ICC
INTERNATIONAL
CODE COUNCIL®

2021 International Energy Conservation Code

Code Change Proposal Tracking Sheet

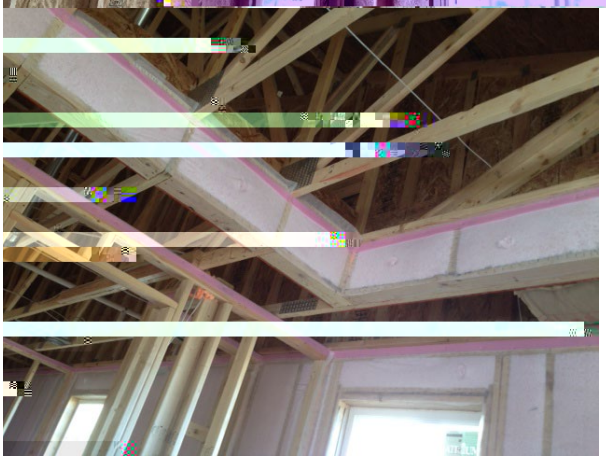
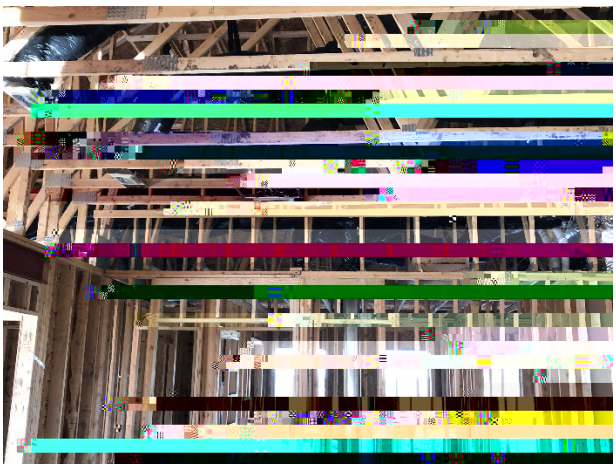
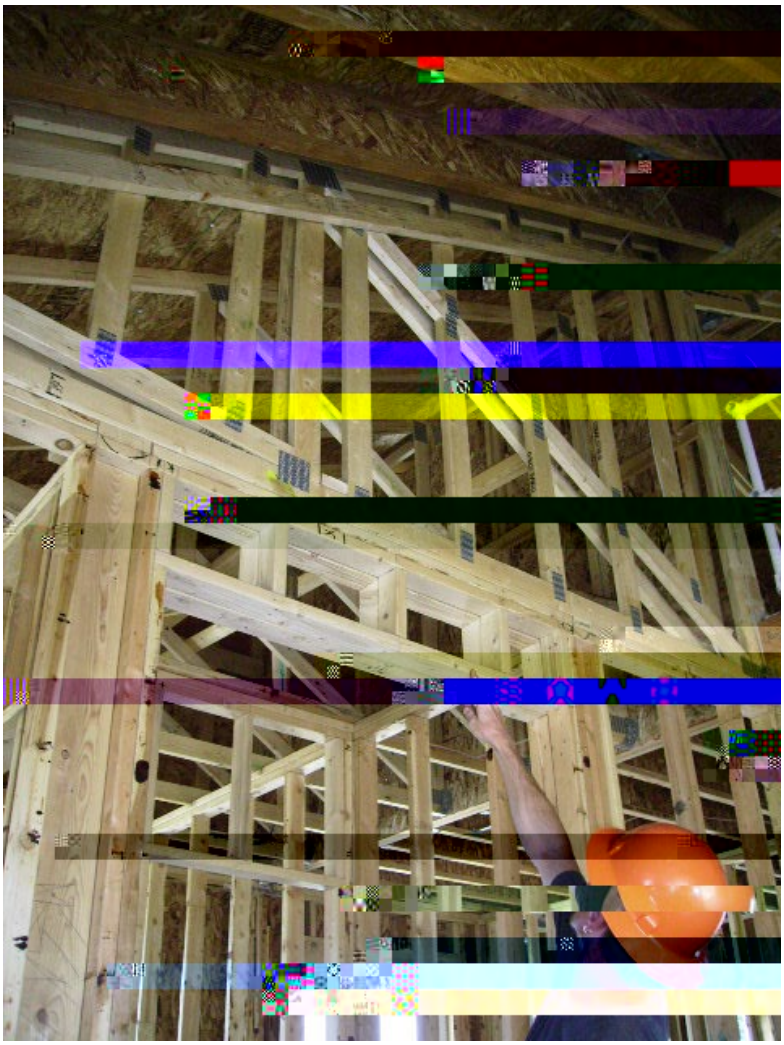
Raised ceiling that protrude into the attic are unique knee wall applications on which the code offers no guidance. They are particularly troublesome for maintaining the continuity of the building thermal envelope and therefore have been added to this section as a means to define when the vertical or diagonal surface must be treated as a knee wall and when attic insulation can be mounded over the raised ceiling.

TABLE R402.1.3

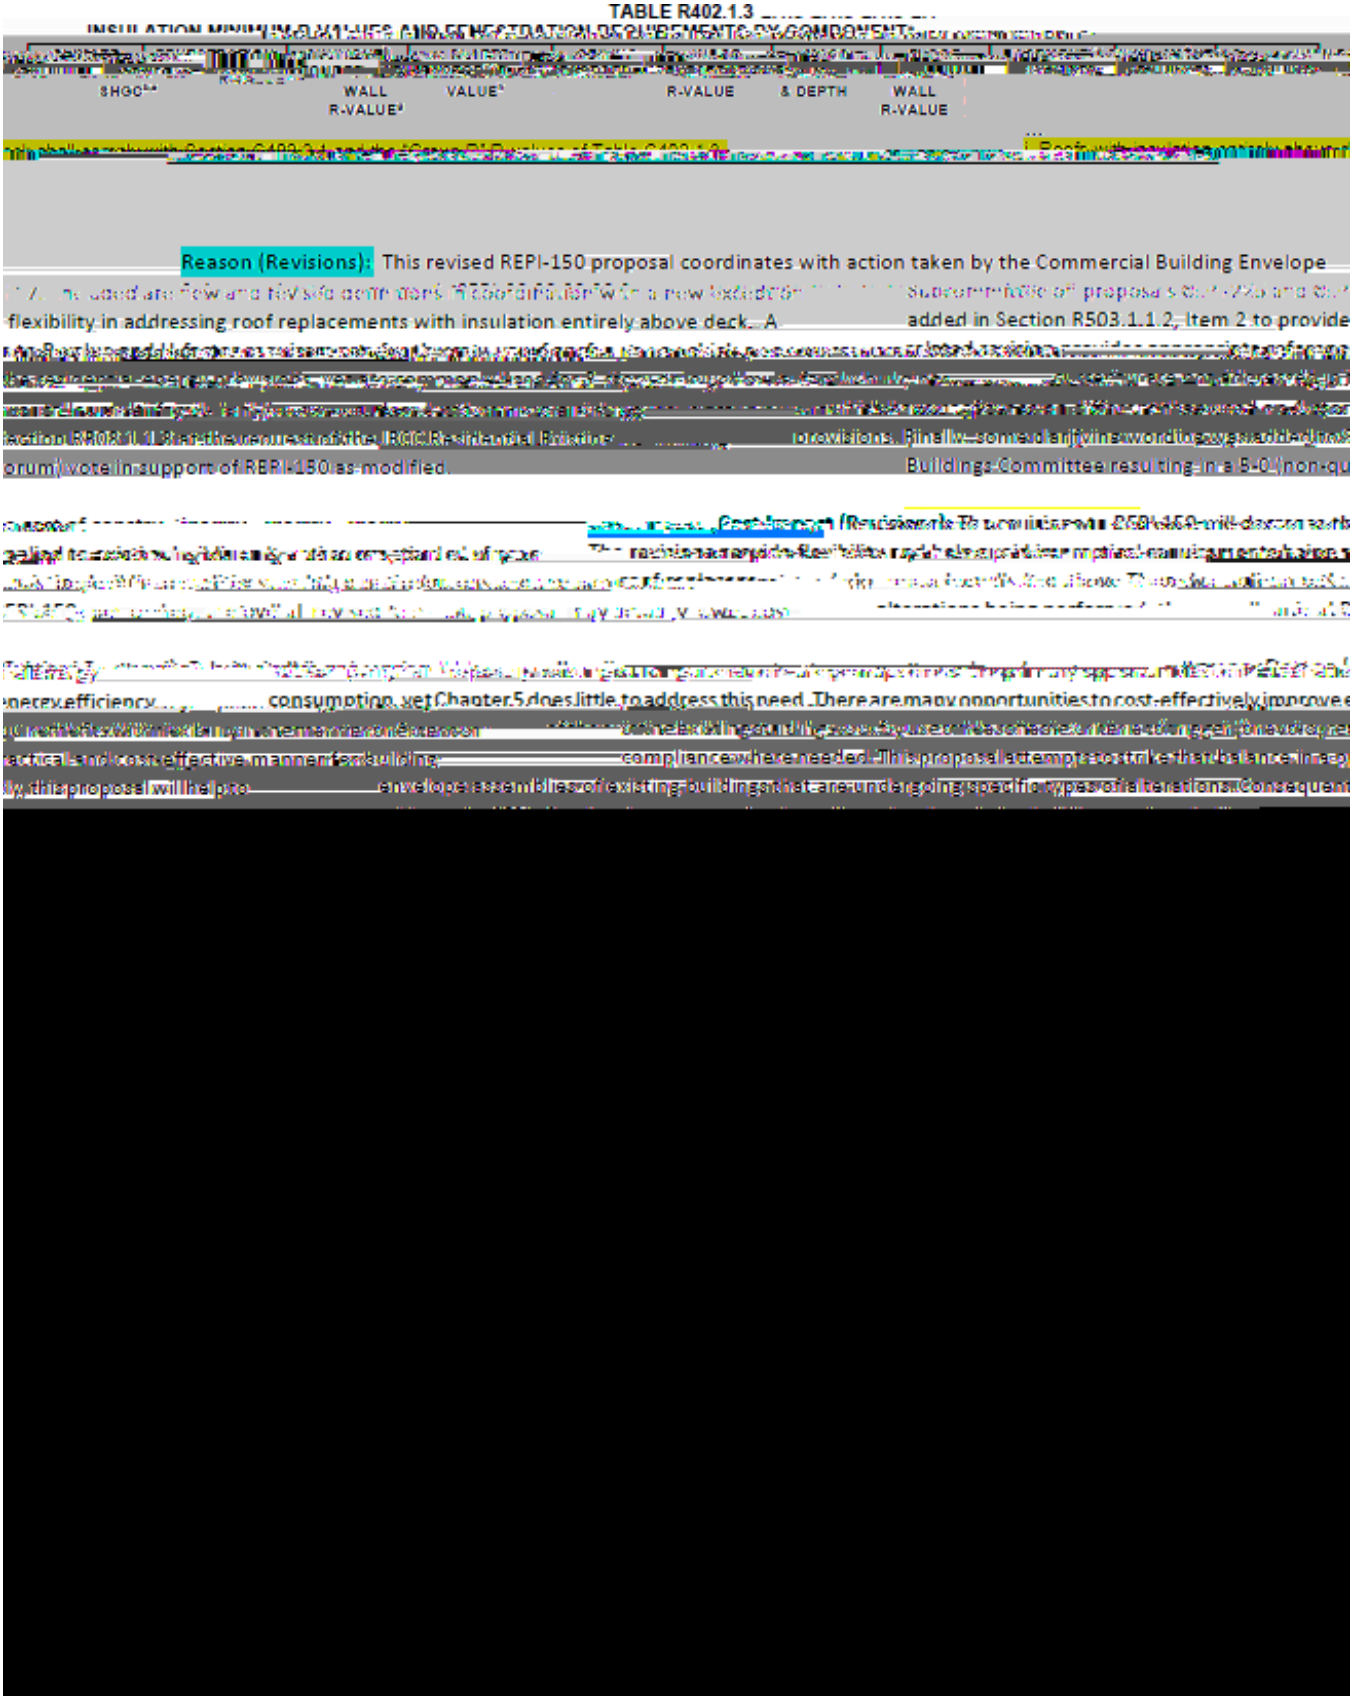
Reason (Revisions): This revised REPI-150 proposal coordinates with action taken by the Commercial Building Envelope
